CORRESPONDENCE RECEIVED
REGARDING CONDITIONAL USE PERMIT #1238

Subject: "The Hub" project. Yosemite Ave. and McKee Rd. Merced, Ca. Conditional Use Permit #1238 Initial Study #19-37. City of Merced Planning Commission Resolution #4035. Previous CUP #1231.CEQA Review and reports. Merced Holdings, LP.

Ref: CUP #1238 for 214 Apartments SE Corner Yosemite Avenue & McKee Road

Re: Site Plan Review #455
Merced Holdings LP Project at Yosemite Avenue and McKee Road
Objections to Approval of Site Plan
Planning Commission Hearing Date: April 13, 2020 at 7:00 p.m.

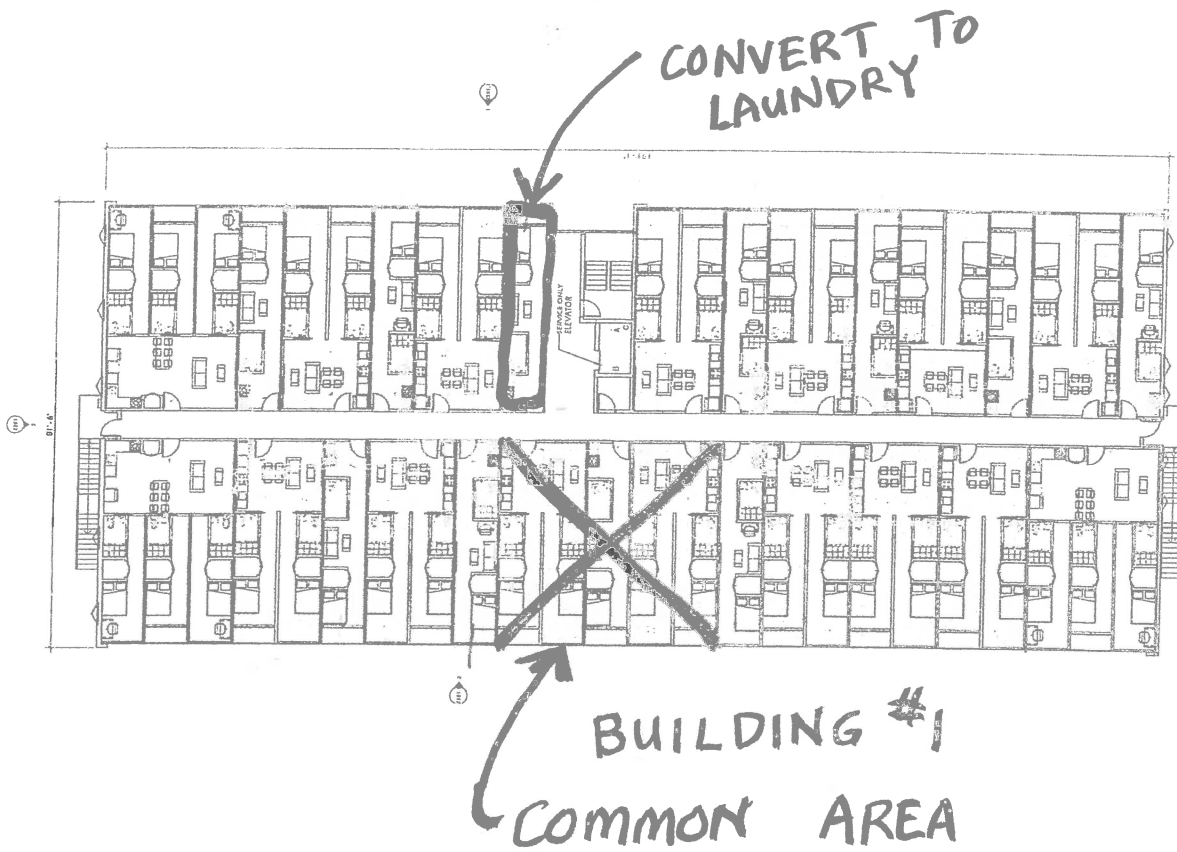
- 4) Building #1 Create common courtyard for tenants at the landing of the apartment stairs by converting three apartments to a courtyard. Convert one apartment area to a laundry. (See Attached Plan)
- 5) Building #2 and #3 Similarly, create a common courtyard for tenants at the landing of the apartment stairs by converting three apartments to a courtyard.
- 6) Change the design so that EVERY apartment has a balcony of a minimum size of 8 feet by 8 feet..

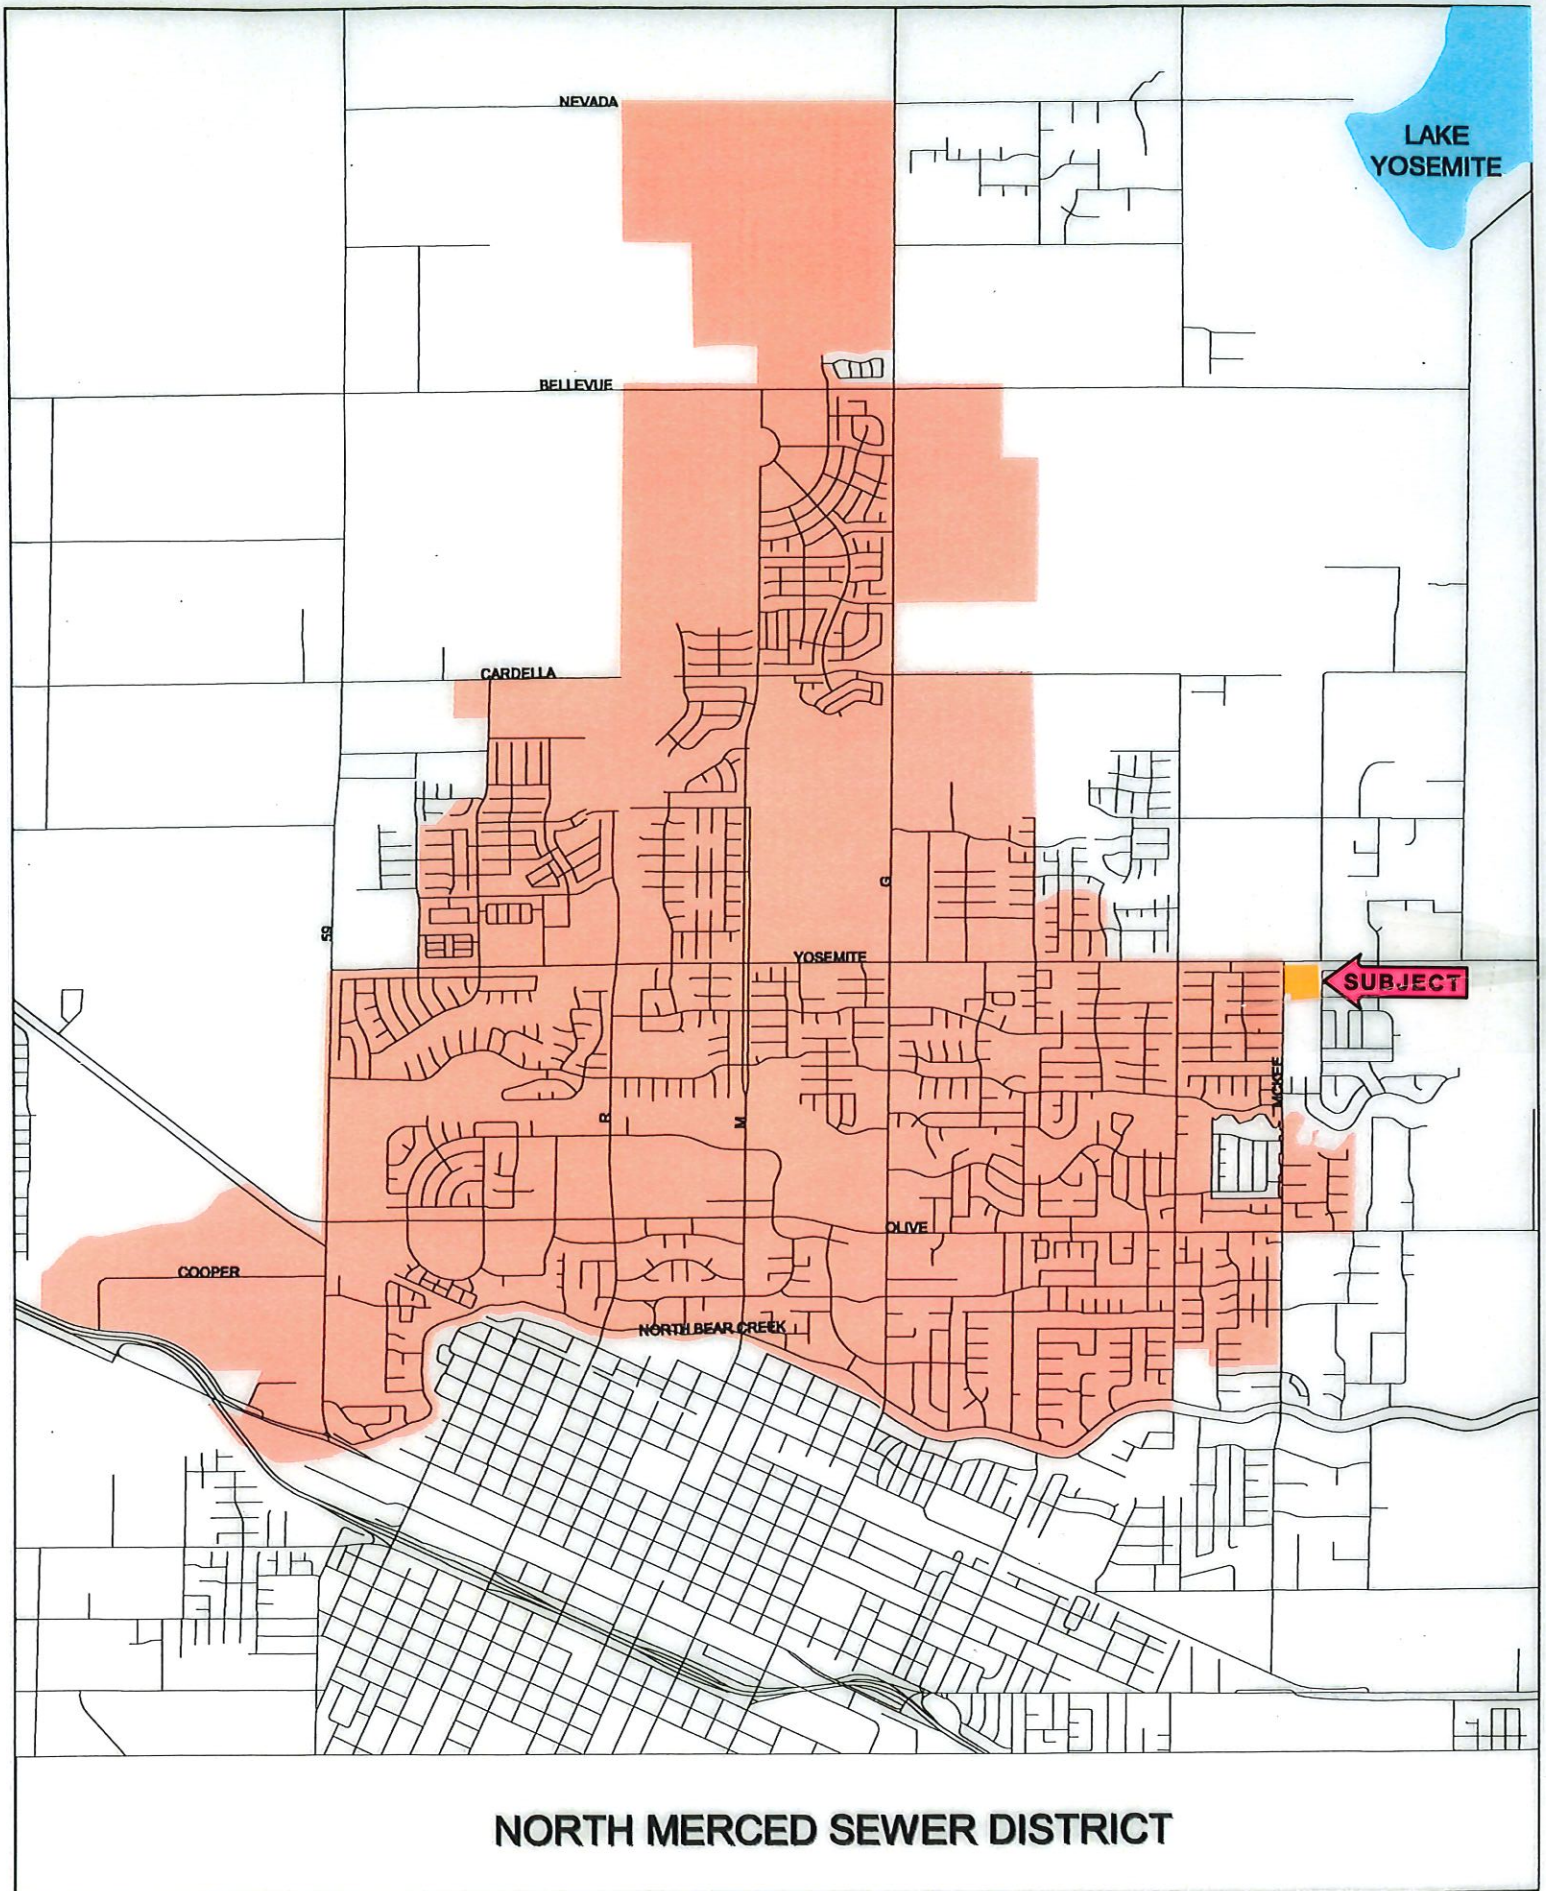
The City of Merced does *not* have a sewer master plan. The subject property is *not* within the North Merced Sewer District (NMSD) boundary (see the attached boundary map with the NMSD area shaded).
